Xcel Energy

Docket No.: E002/M-17-777

Response To: MN Public Utilities Information Request No. 1  
Commission

**Figure 1: Illustrative Hosting Capacity Planning Interface and Assessment**

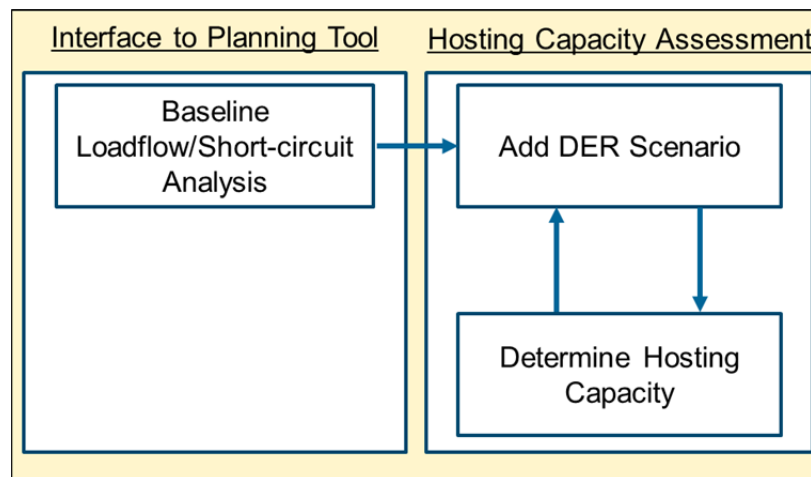
Please provide a supplemental, publicly available description of the detailed methodology, including analytic equations where appropriate, for the streamlined hosting capacity analysis Xcel Energy performed.

- a. The steps in Xcel's methodology (as an example see pages 27-66 of the PG&E report referenced above);
- b. Datasets, Tools, and Tool Capabilities (example from PG&E report on pages 34-36);
- c. Power System Criteria and Calculation Techniques (example from PG&E report on pages 47-66)

Once the models have been extracted, DRIVE can perform the necessary analysis. At this point, settings such as the Thresholds or type of DER expected, can be adjusted and the hosting capacity analysis is ultimately run. On average, it takes about 3-5 minutes per feeder to run the analysis. Once it has finished running, a report based on the DER allocation method is generated to establish the tabular results as seen in Attachment A of our hosting capacity report.

In the figure below, DRIVE-MAI is represented by the “Interface to Planning Tool” heading while DRIVE is represented by the “Hosting Capacity Assessment” heading. Within DRIVE, the Power System Criteria and Calculations Techniques are applied in the box labeled “Determine Hosting Capacity,” while the “Add DER Scenario” box refers to the configurability of the type of DER allocation.

**Figure 1: Forecast of EV counts under Low, High, and Likely EV Penetration Scenarios**

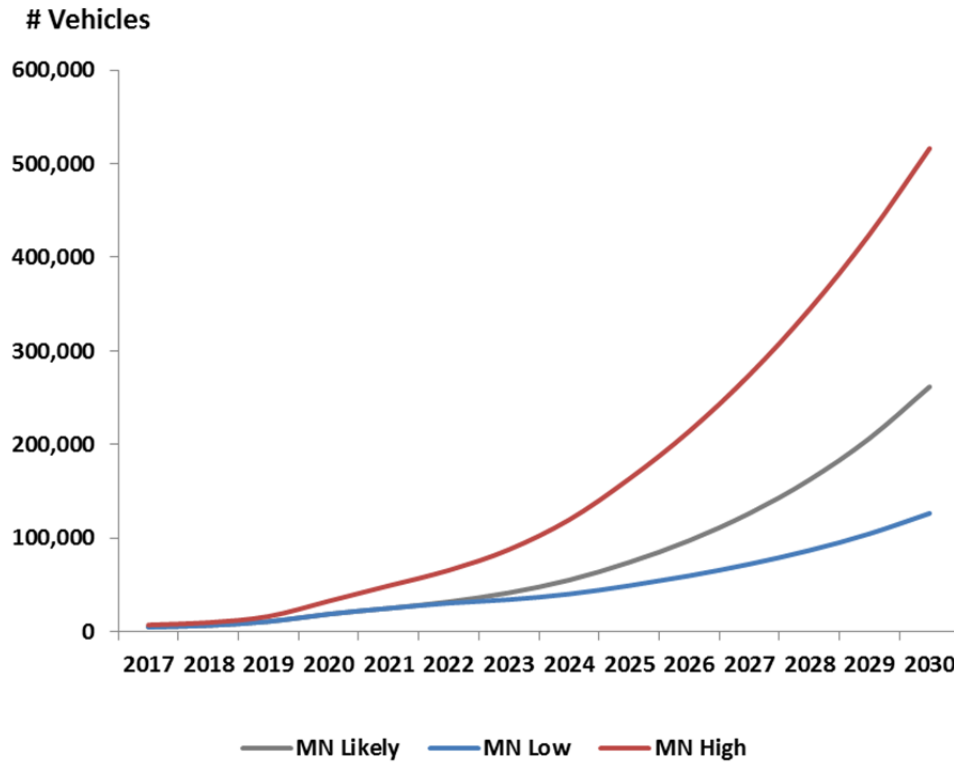
Xcel Energy states that, “Due to the nascent nature of the energy storage market in Minnesota, we excluded energy storage load characteristics from our analysis. However, in the future we plan to monitor the ability of our hosting capacity tool with regard to energy storage, and work to extract value where it exists” (page 7). Please quantify the amount of existing energy storage on Xcel’s system (number of storage installations, megawatt capacity) and provide a forecast of the increase in energy storage, including both battery storage and electric vehicles, over the next five years and the next 10 years.

We have a Low, High, and Likely forecast of electric vehicle counts in our Minnesota service territory, which is based on an internally-developed methodology that incorporates both economic payback and Bass diffusion (technology adoption) model. The scenarios are created based on gasoline prices to derive adoption estimates. The likely scenario is formulated by taking a weighted average adoption of the economic and Bass diffusion models<sup>1</sup>. See Figure 1 below.
